Addendum 98: Regulation No. 99

Revision 2 – Amendment 3

Supplement 7 to the original version of the Regulation - Date of entry into force: 26 July 2012

Uniform provisions concerning the approval of gas-discharge light sources for use in approved gas-discharge lamp units of power-driven vehicles

Sheet D5S/1

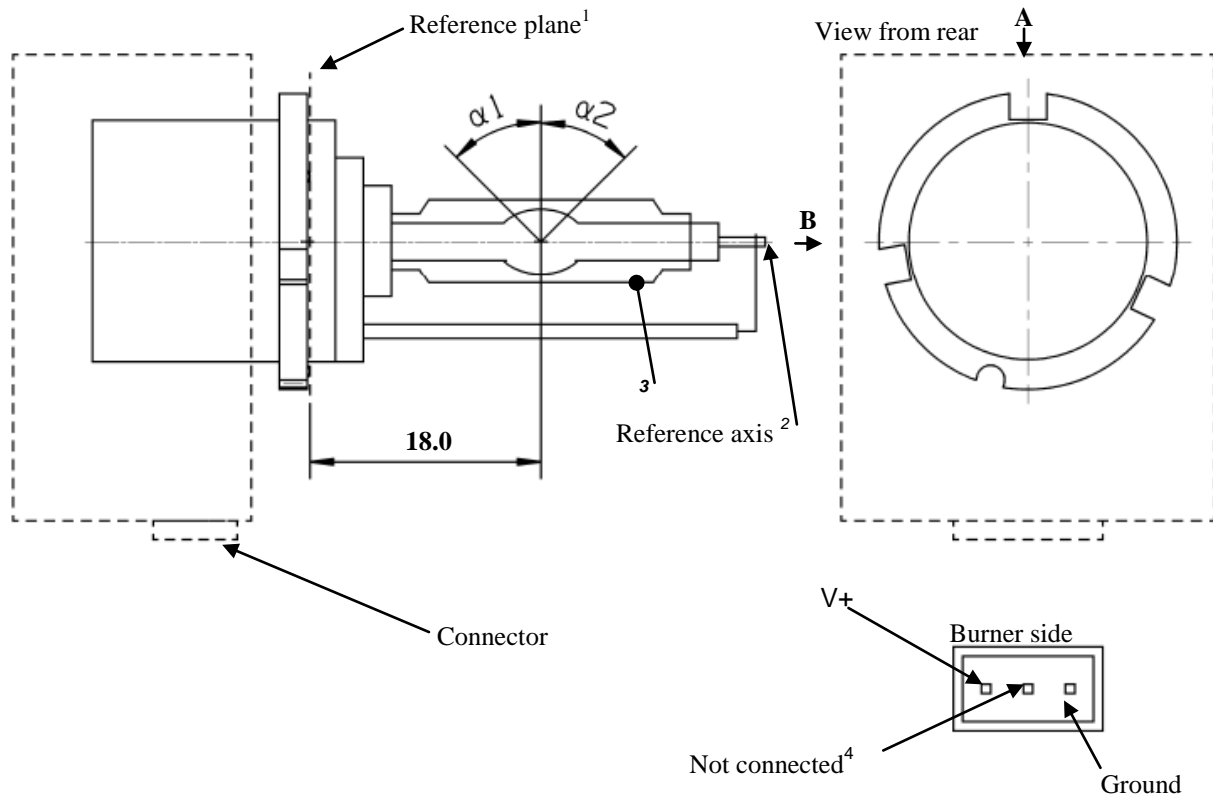
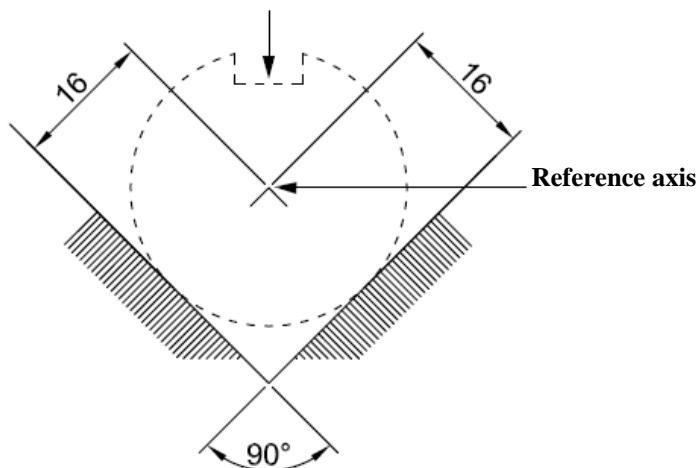
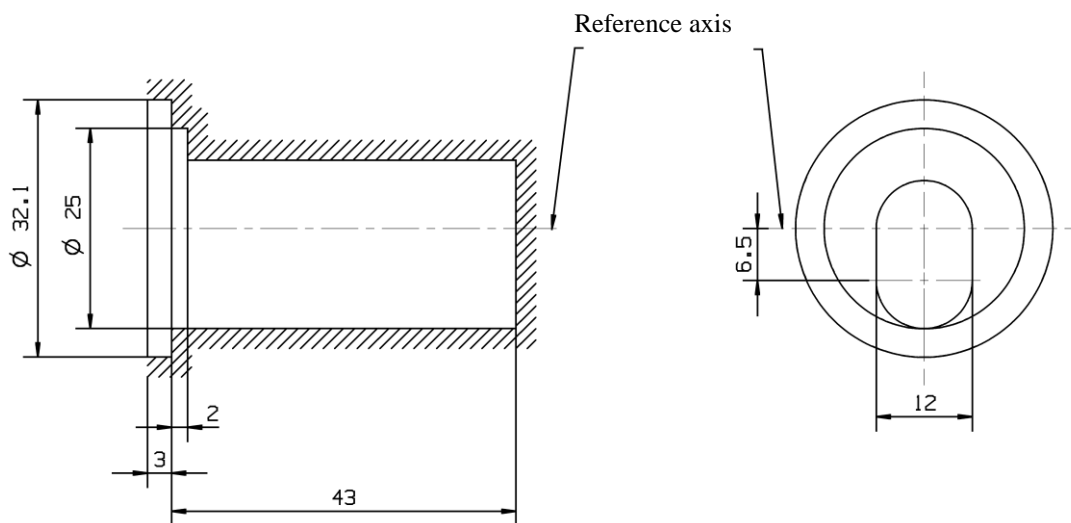
Insert new sheets D5S/1 to 5, D6S/1 to 5 and D8S/1 to 5 after DxS/6, to read:

¹ The reference plane is defined by the positions on the surface of the holder on which the three supporting bosses of the cap ring will rest.

² See sheet D5S/2.

³ When measured at a distance of 18.0 mm from the reference plane and with respect to the mid-point of the inner bulb, the outer bulb shall have an eccentricity of 1 mm max.

⁴ Optional Pin.

¹ The reference axis is perpendicular to the reference plane and crosses the intersection of the two parallel lines as indicated in figure 2.

² Glass bulb and supports shall not exceed the envelope, as indicated in figure 3. The envelope is concentric with the reference axis.
